Report. hwl30004. 2005-07-01. RCRA - Demolition

Demolition Work Plan

**Bayer MaterialScience LLC
125 New South Road
Hicksville, New York**

July 2005

FIGURE
3

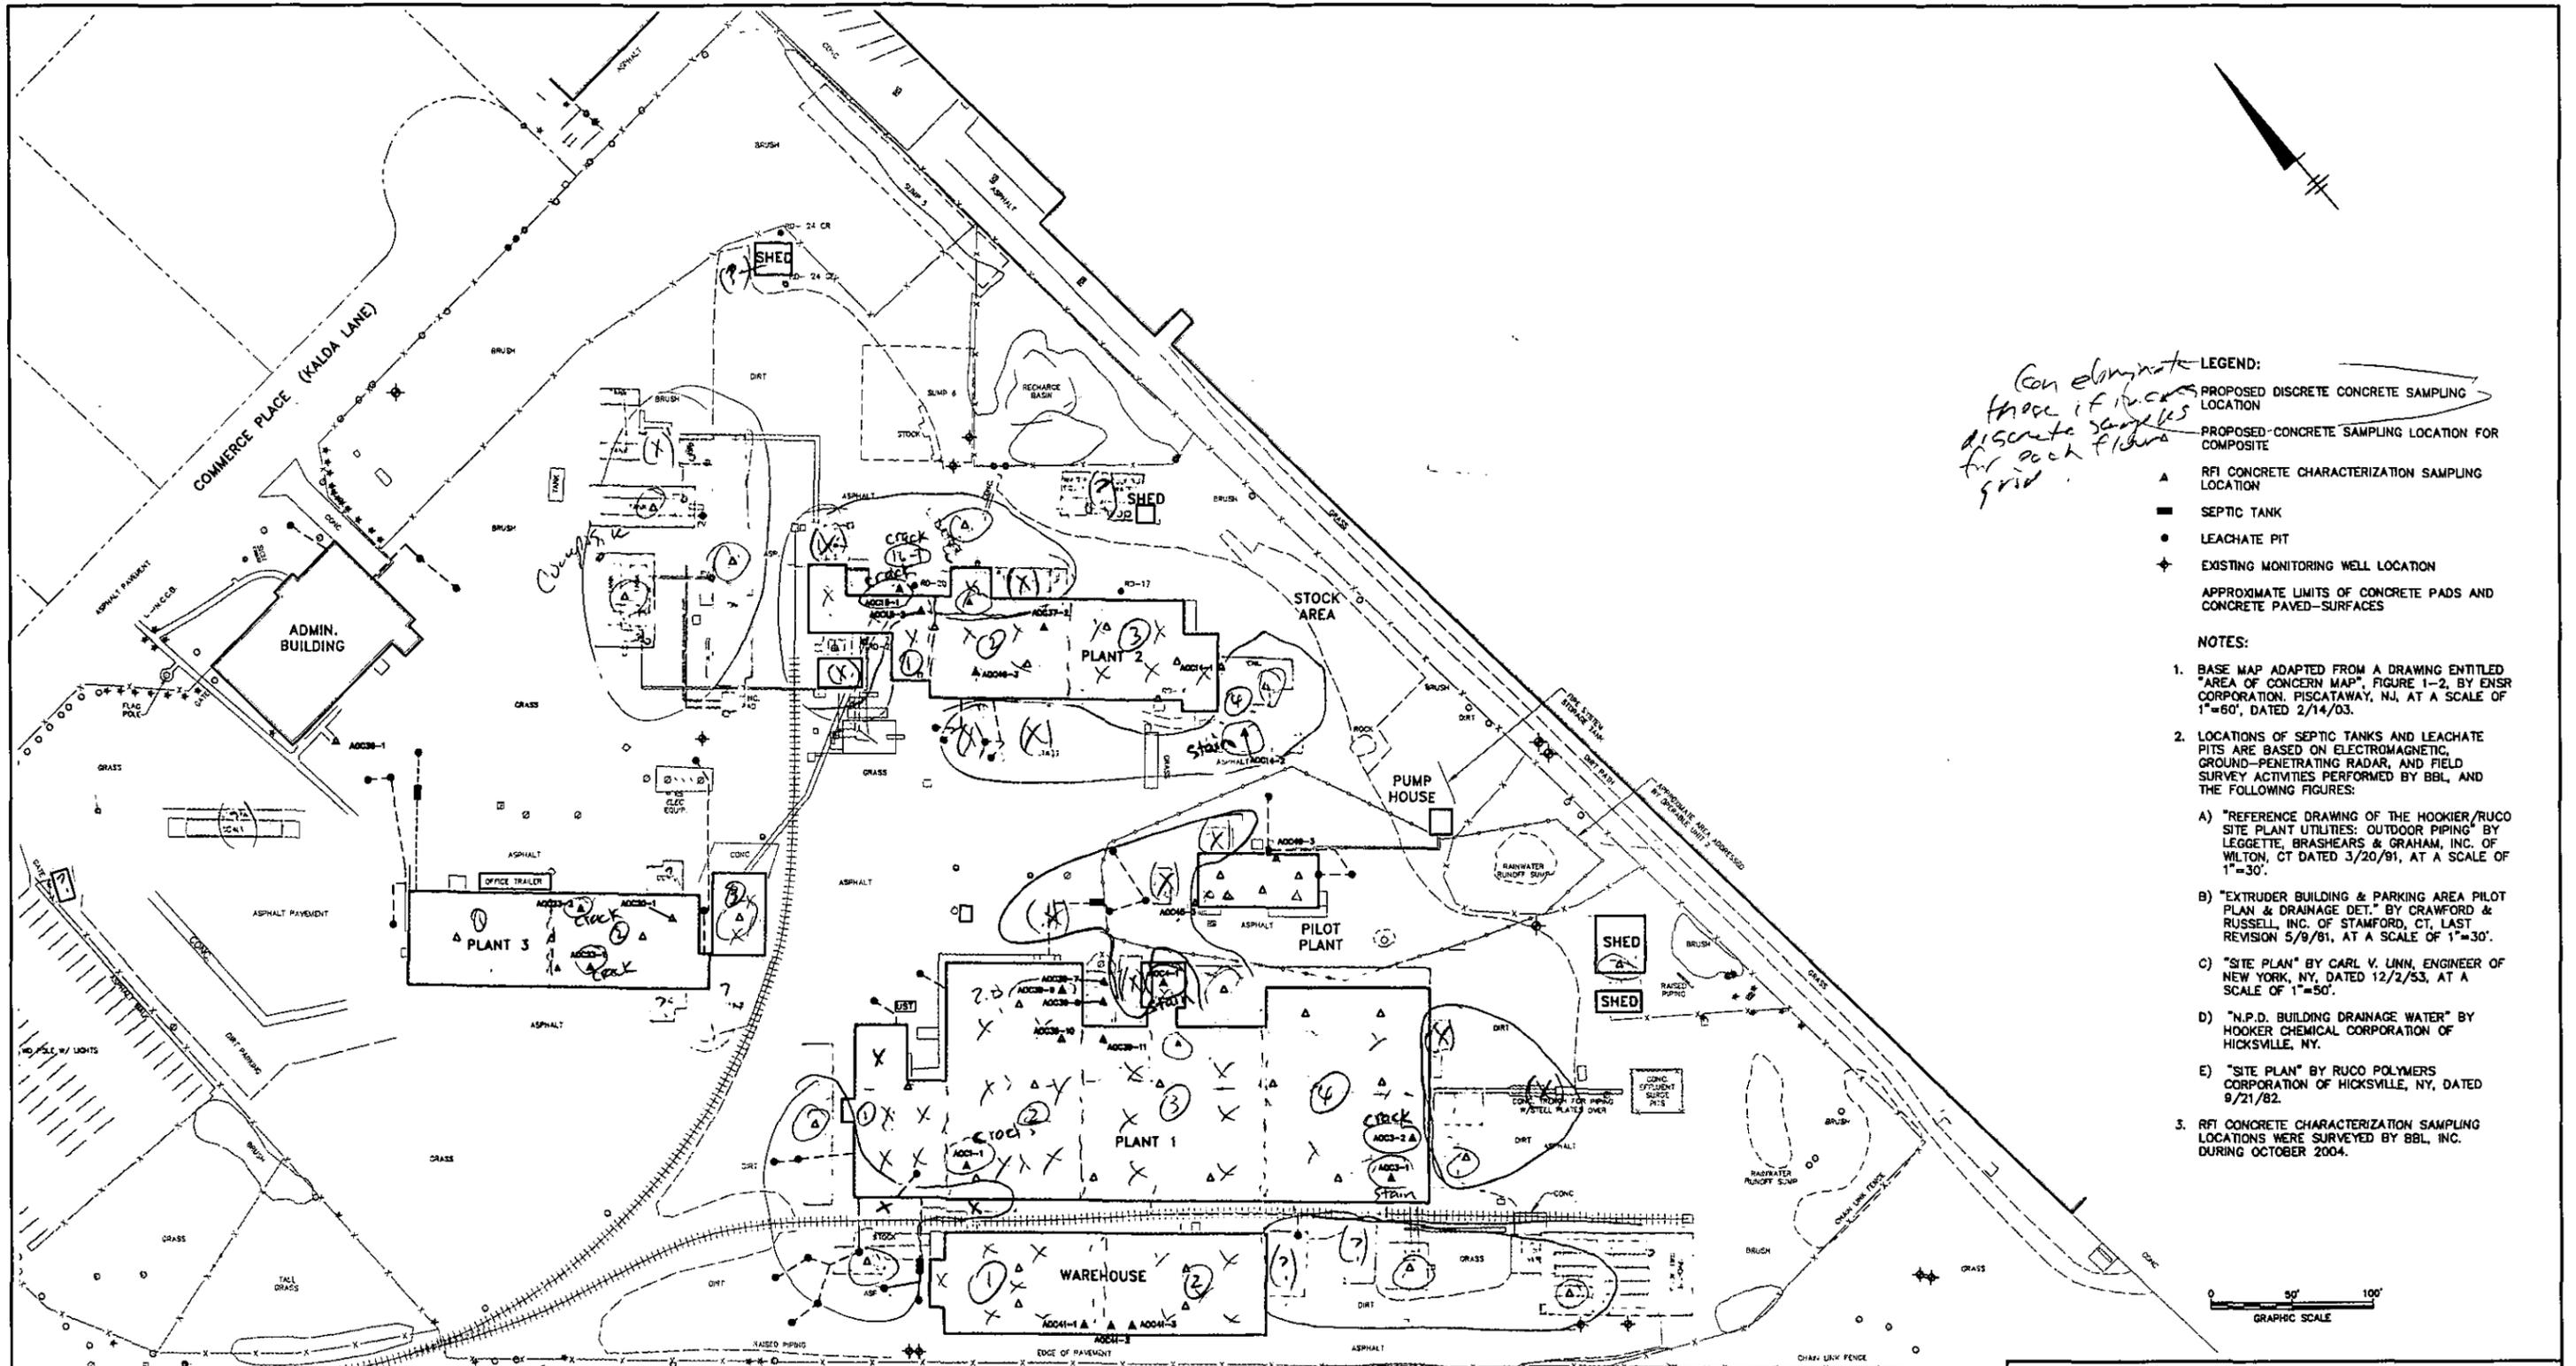
There appear to be many areas which will not be obtained. Need to justify this. See figure 3.

Are these shown on fig 3??

Can eliminate these if it turns discrete samples for each floor grid.

Plant 1 4000 SF

Plant 2

Plant 3

Grid 1 -	(5)	discretes	for (1)	comp	(5400 ft ²)
Grid 2 -	(5)	"	"	"	(")
Grid 3 -	(2)	"	"	"	(4500 ft ²)
	(12)		(3)

FIGURE
4

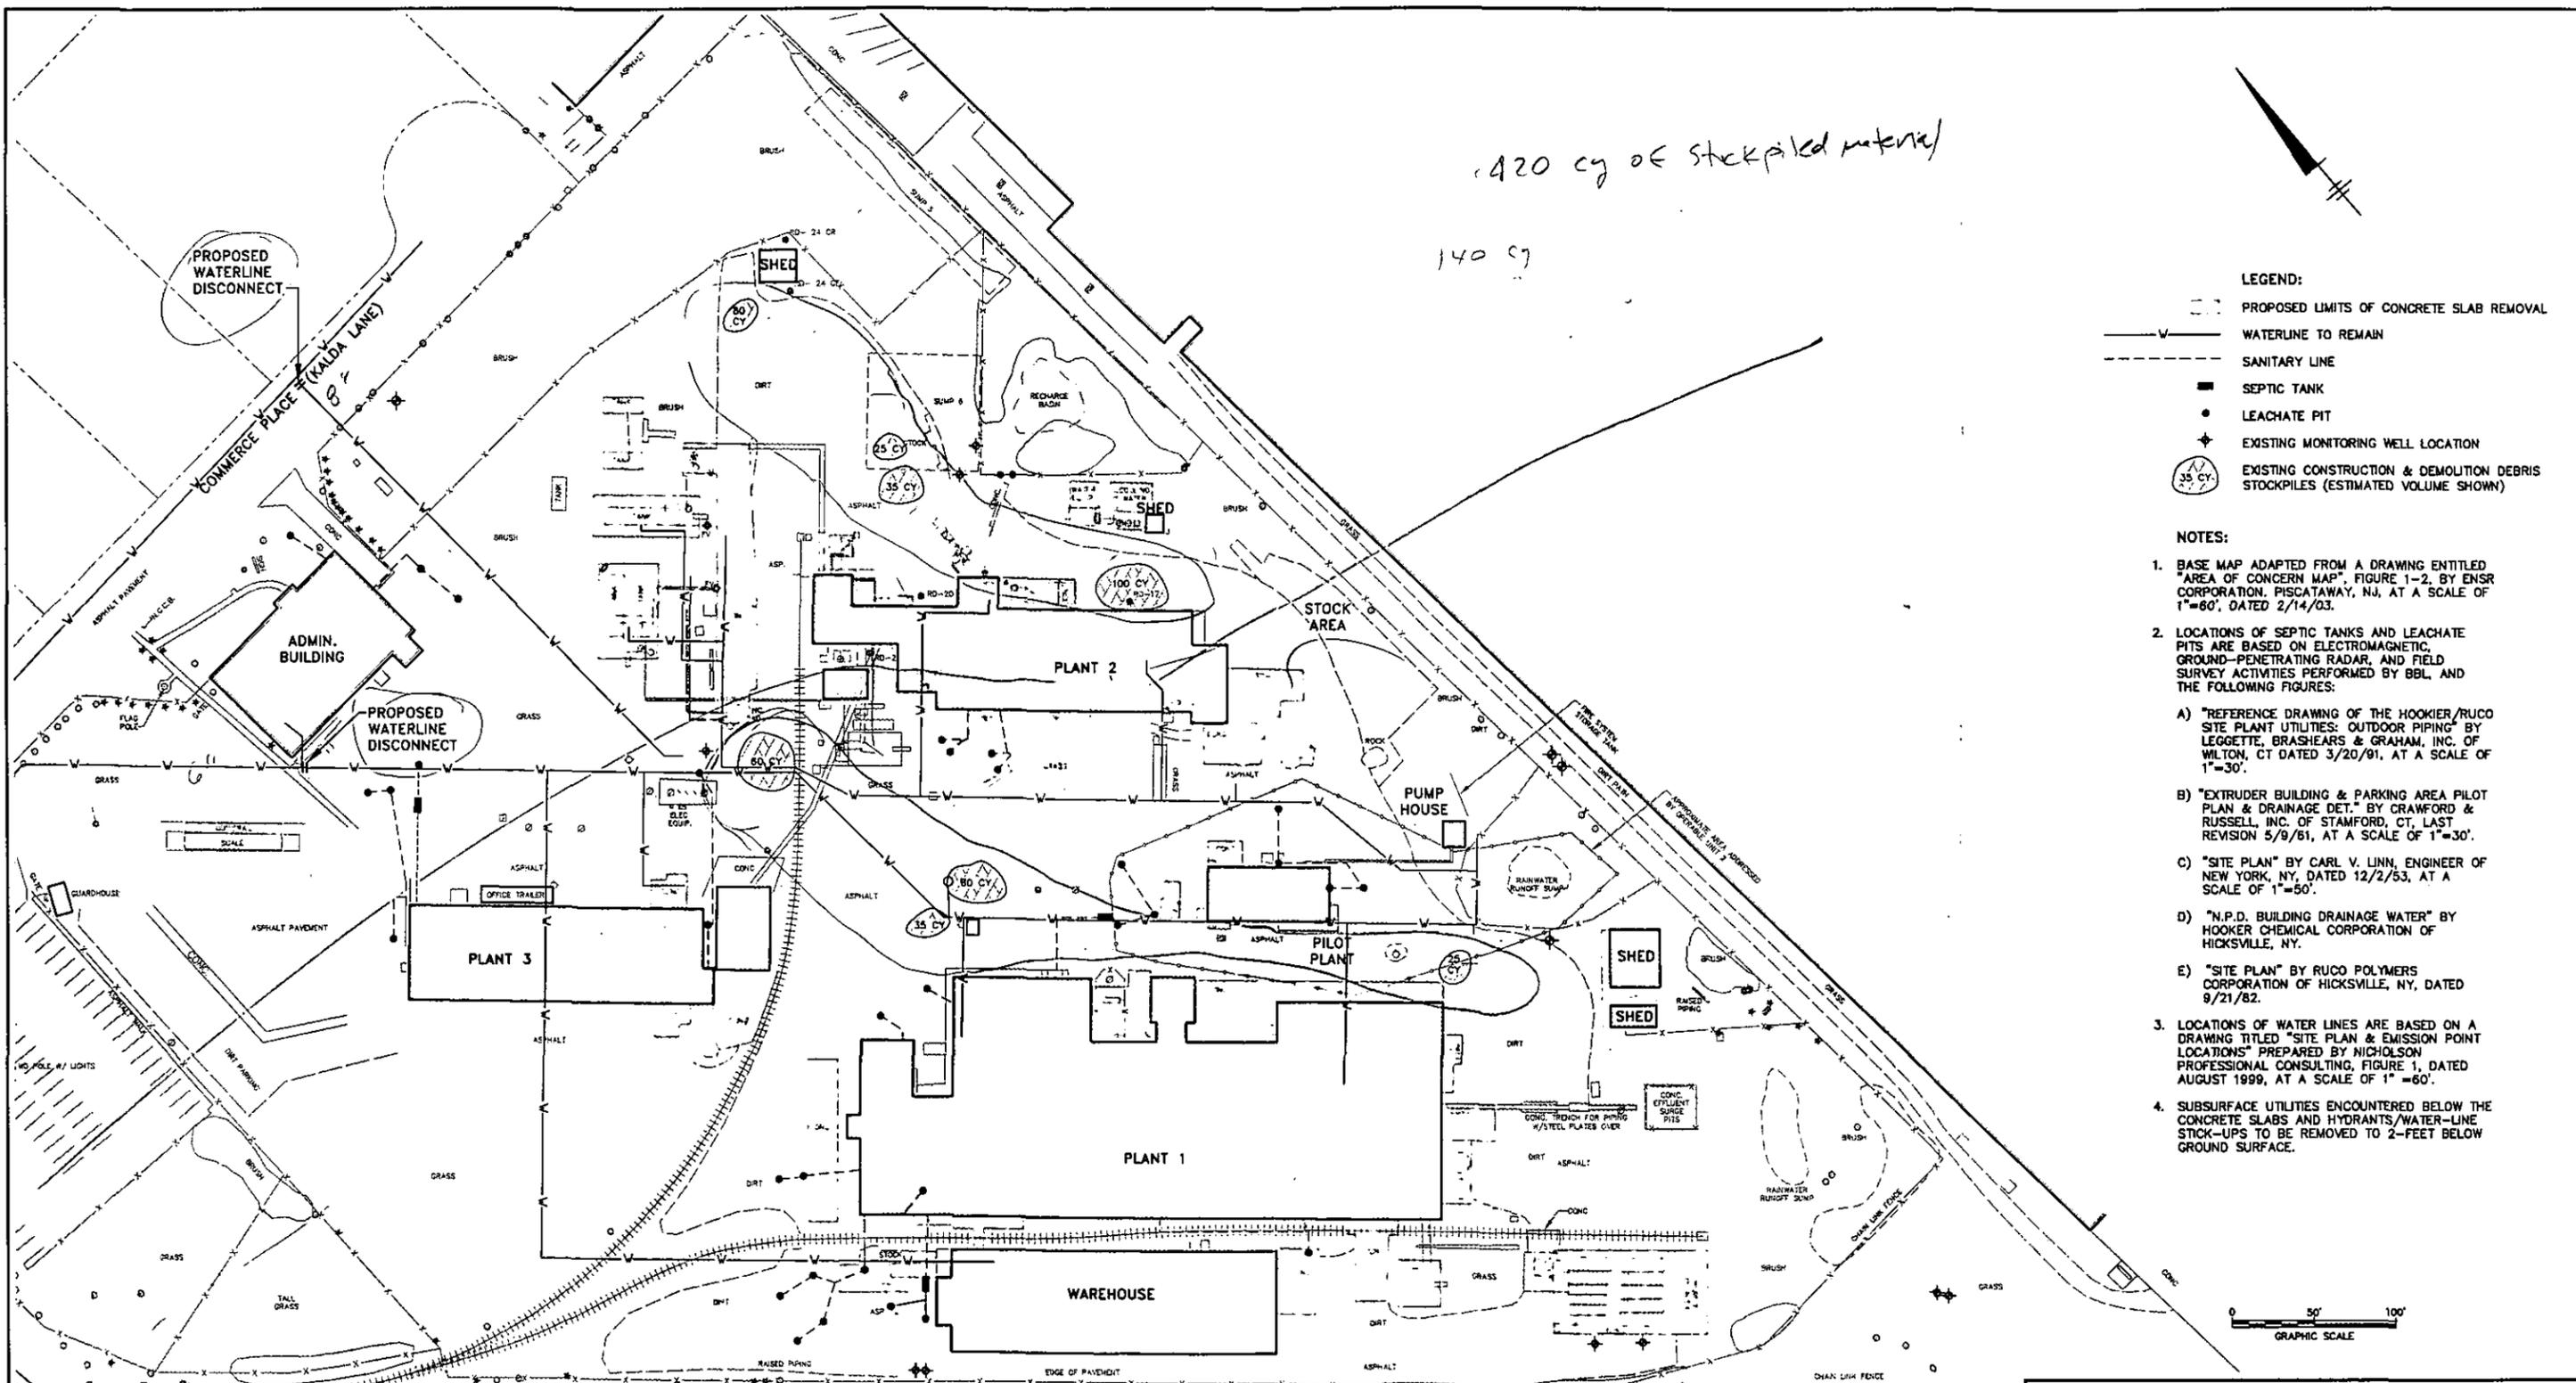
420 cy of stockpiled material

140 cy
